Final Drainage Report

Kristin Estates El Paso County, Colorado

PCD File No.: SF2521

Prepared: June 1, 2026

Worksheet for Roadside Ditch_0+00-9+00

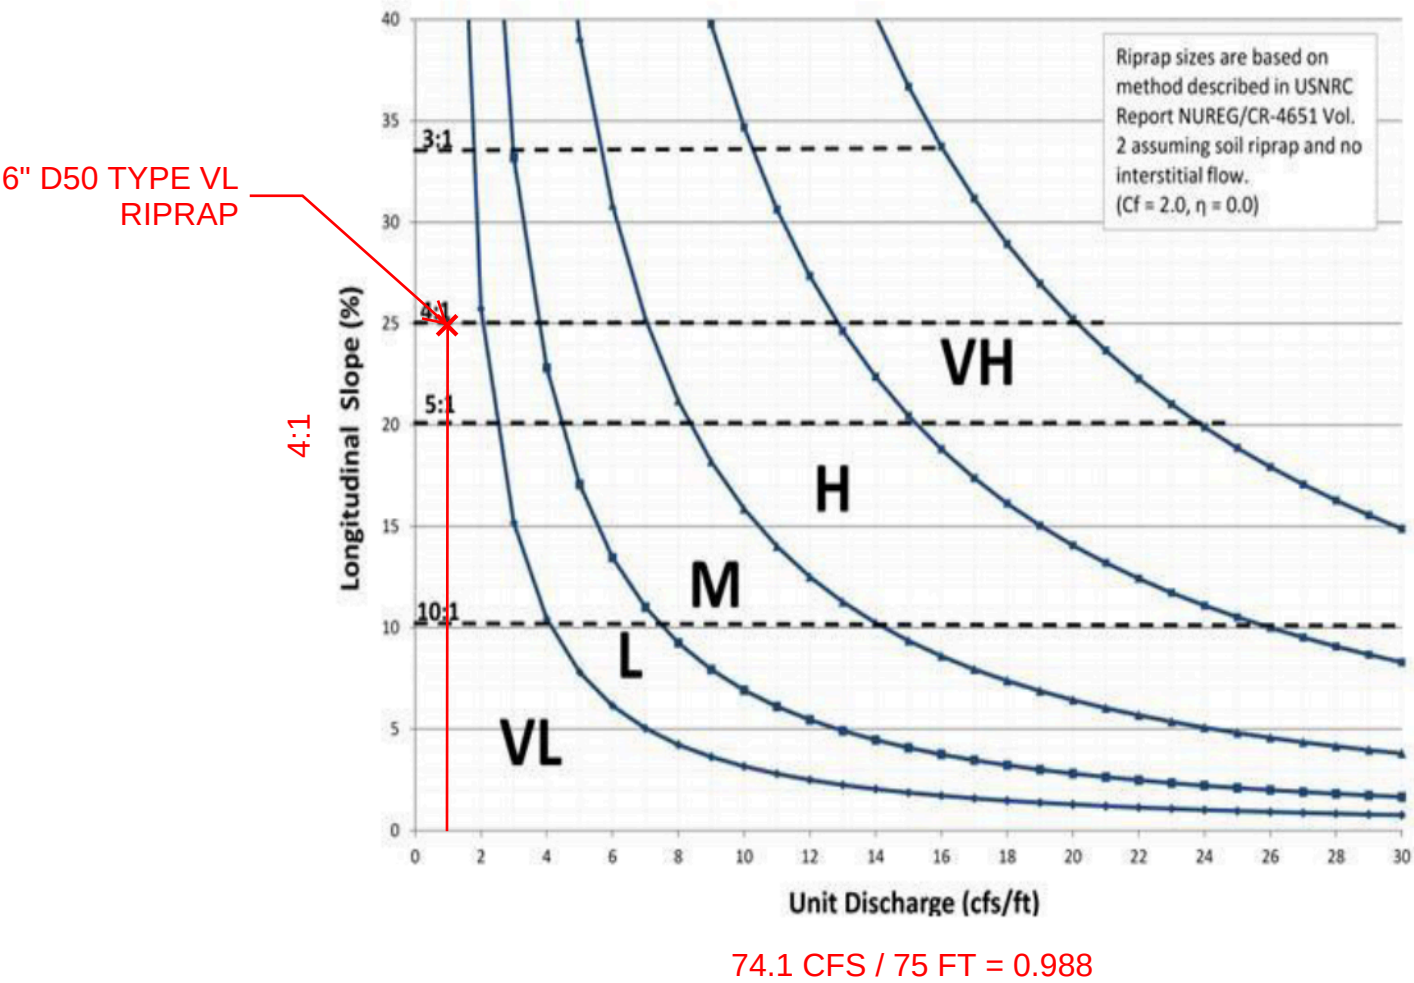
This slope does not appear to match the CD grading and would be a very shallow ditch. Please revise this slope as needed.

KRISTEN ESTATES - EXISTING CONDITIONS DRAINAGE MAP

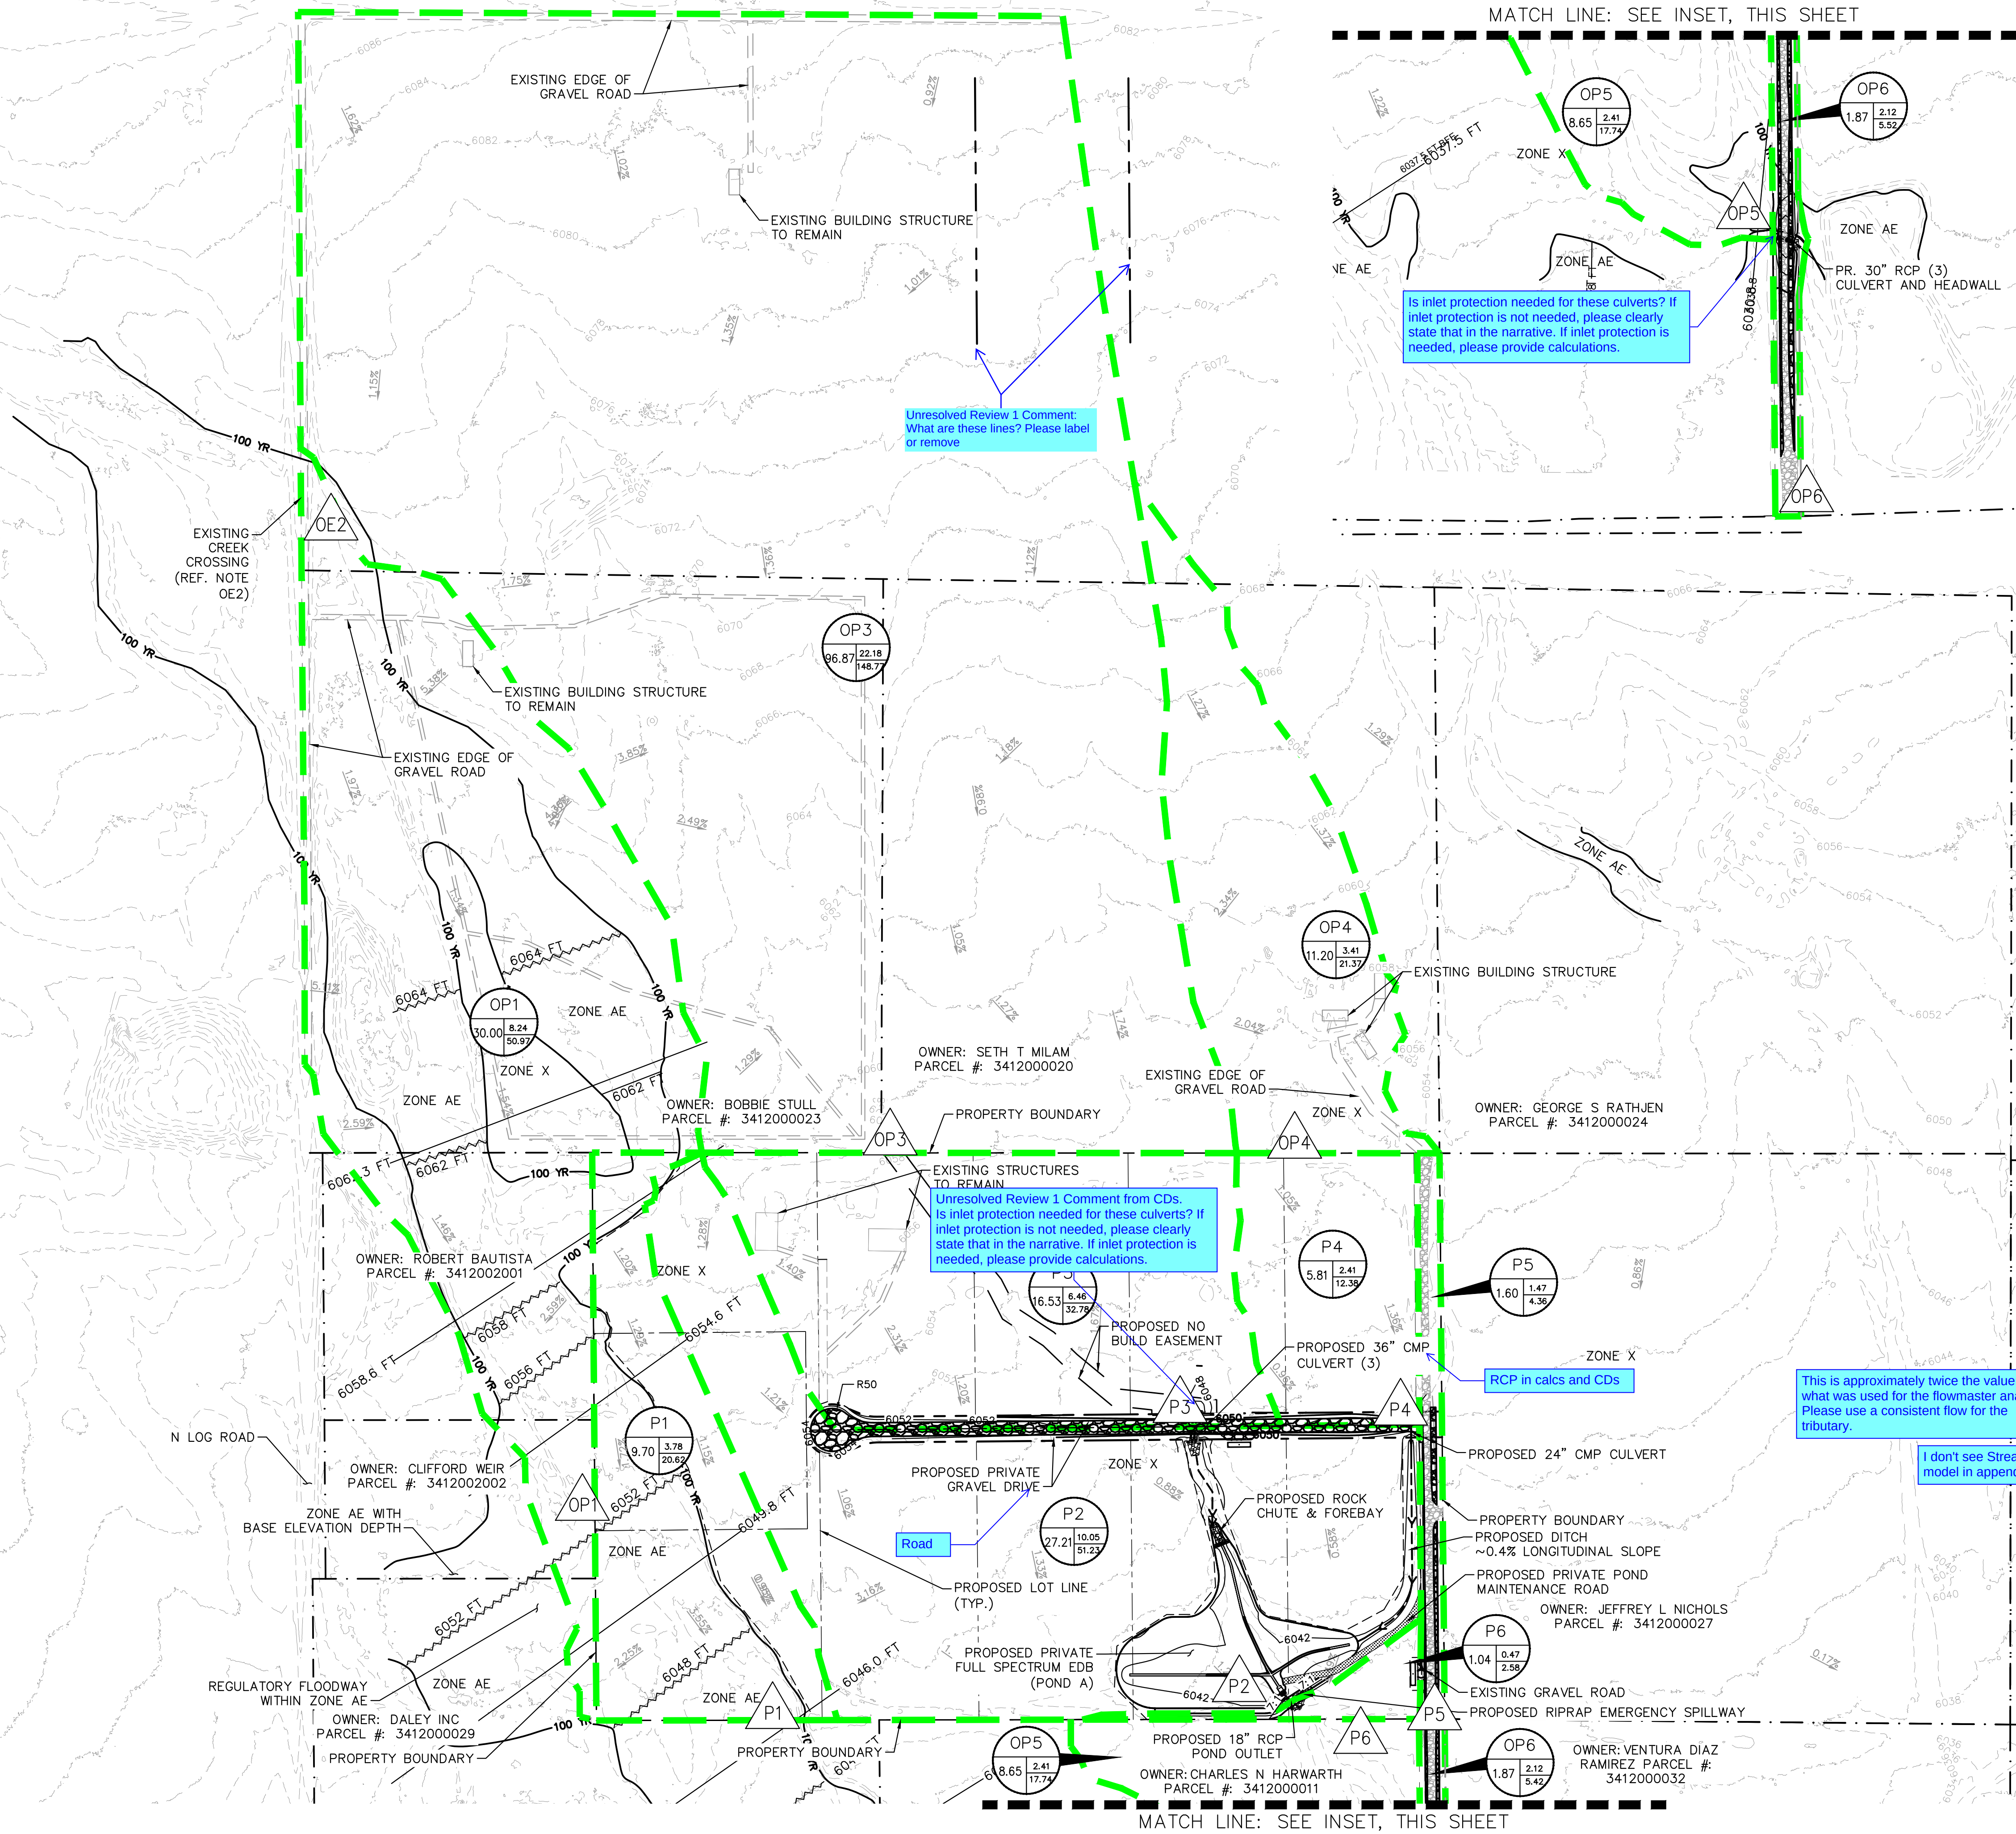
Unresolved Review 1 comment:
Flows at DP OE1 and E1 should be combining with the tributary OE2 flows as it travels across the project site.

Unresolved Review 1 Comment: What are these lines? Please label or remove

KRISTEN ESTATES -
PROPOSED CONDITIONS
DRAINAGE MAP

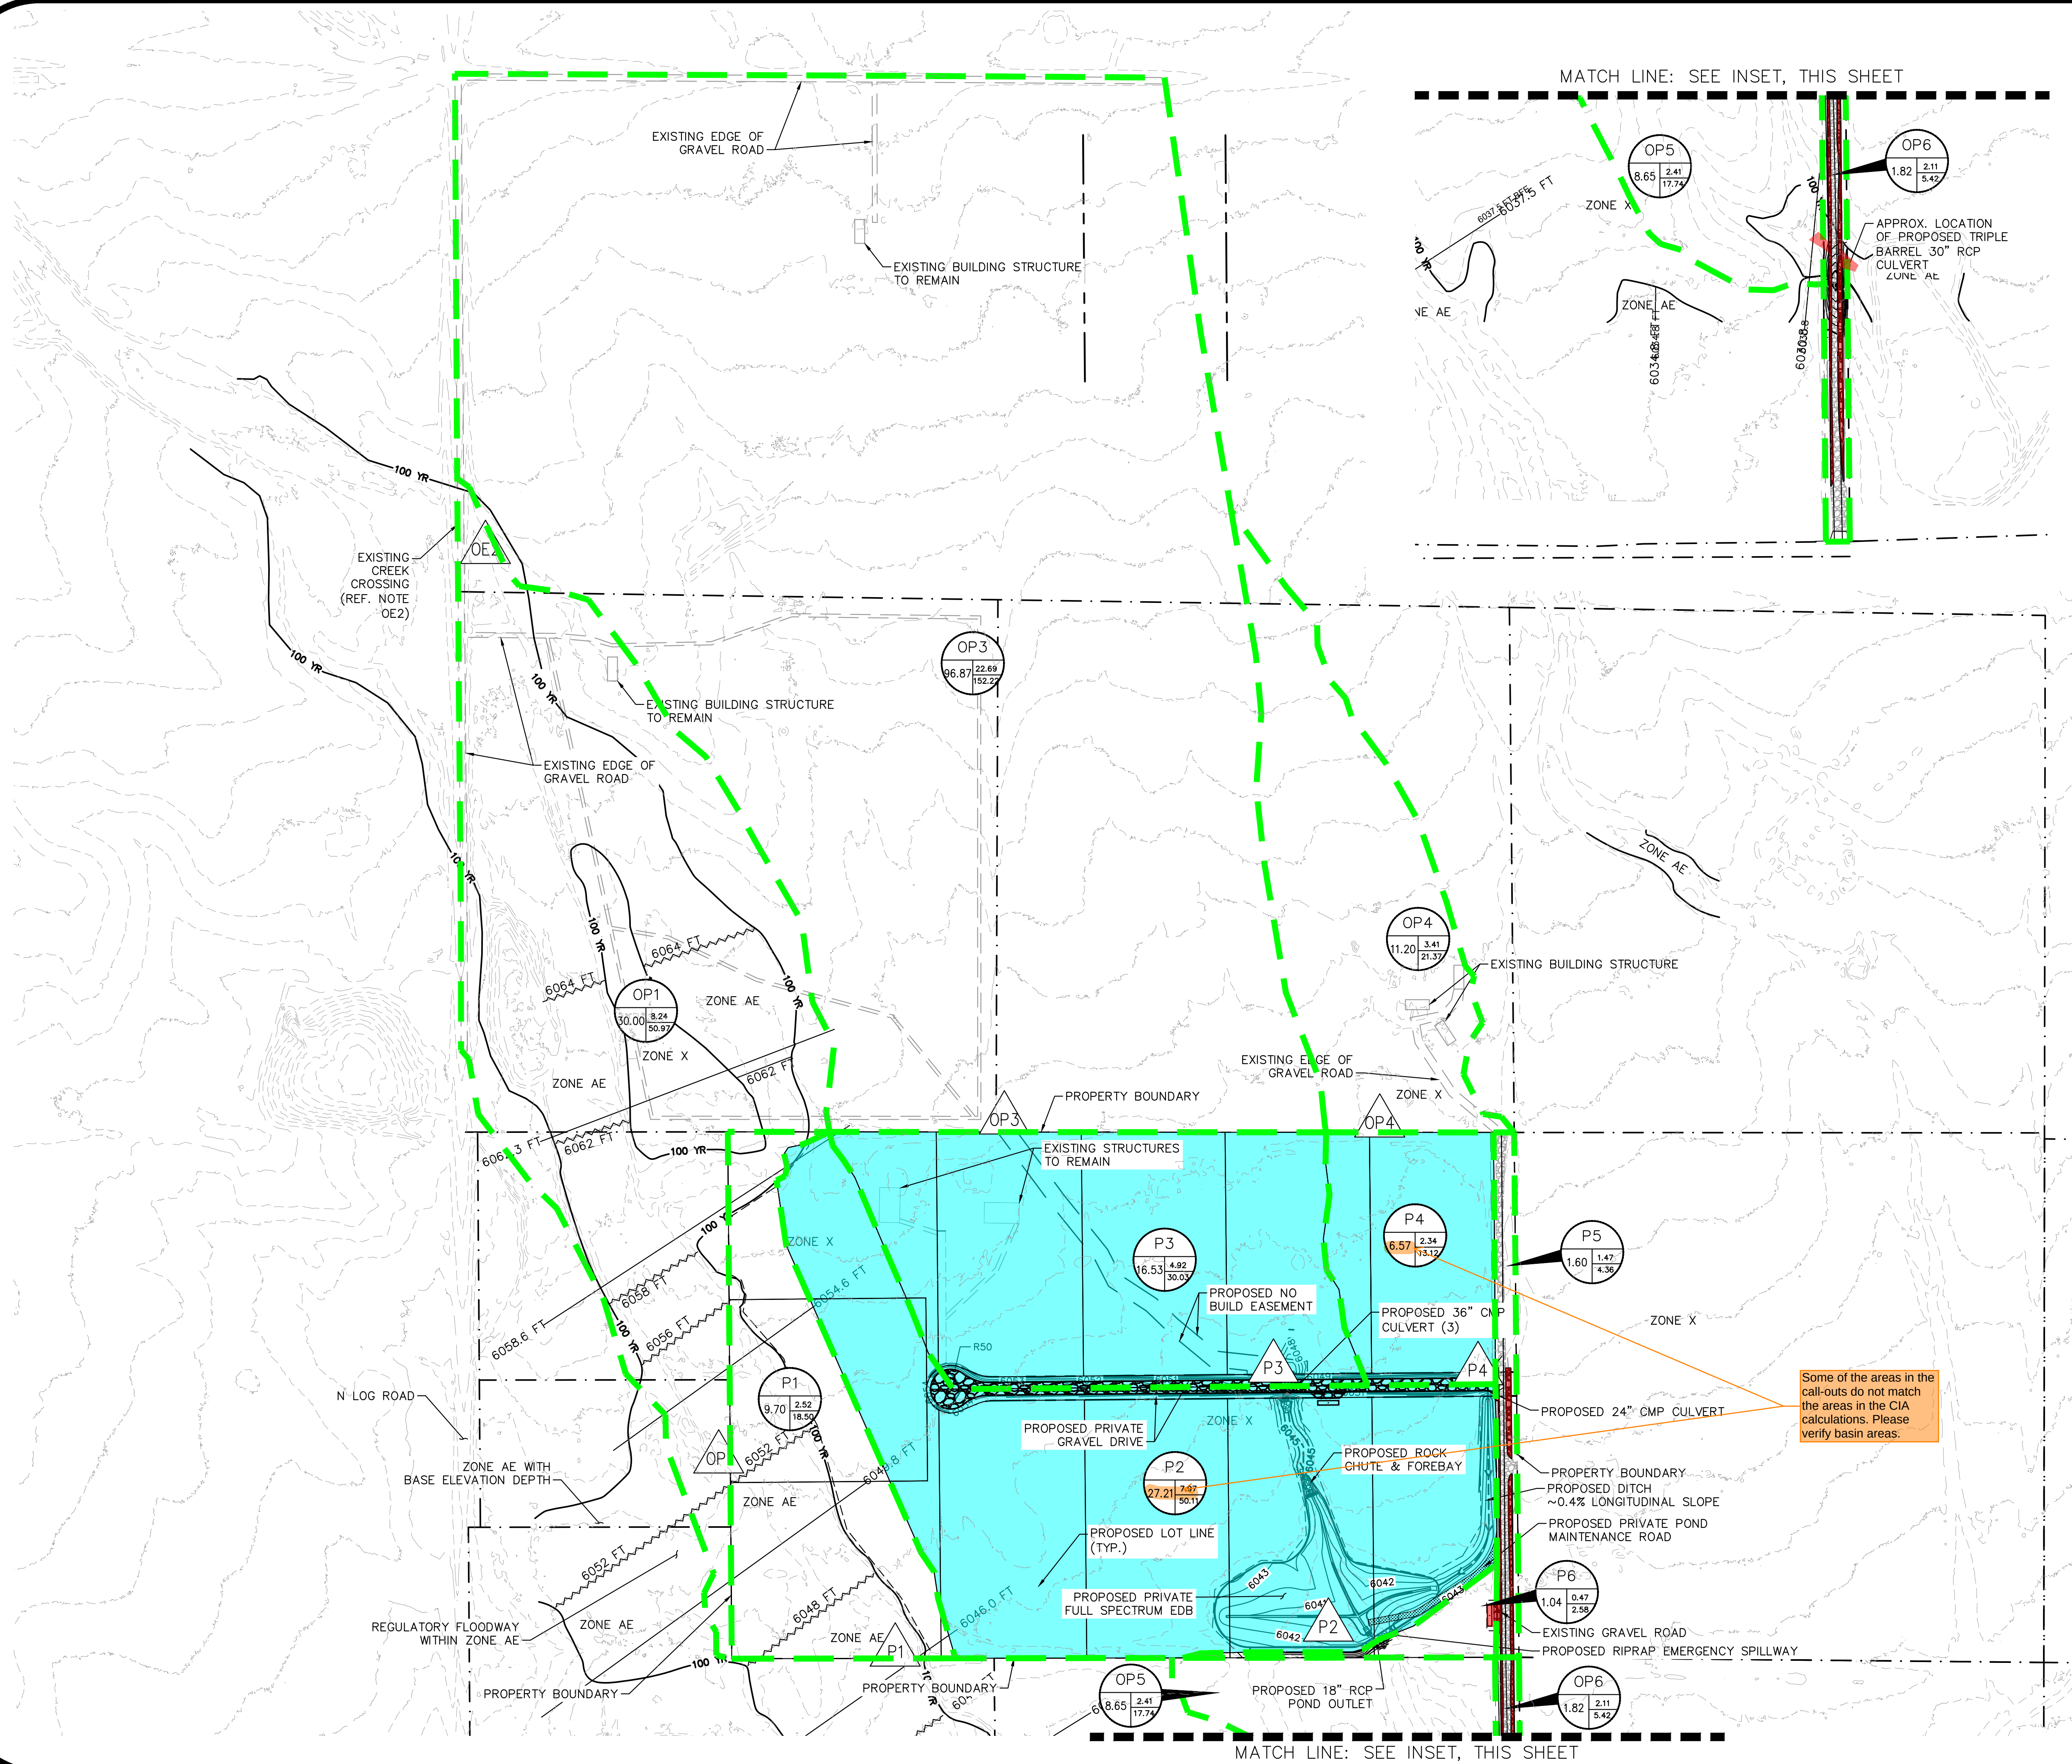
Some of the areas in the call-outs do not match the areas in the CIA calculations. Please verify basin areas.
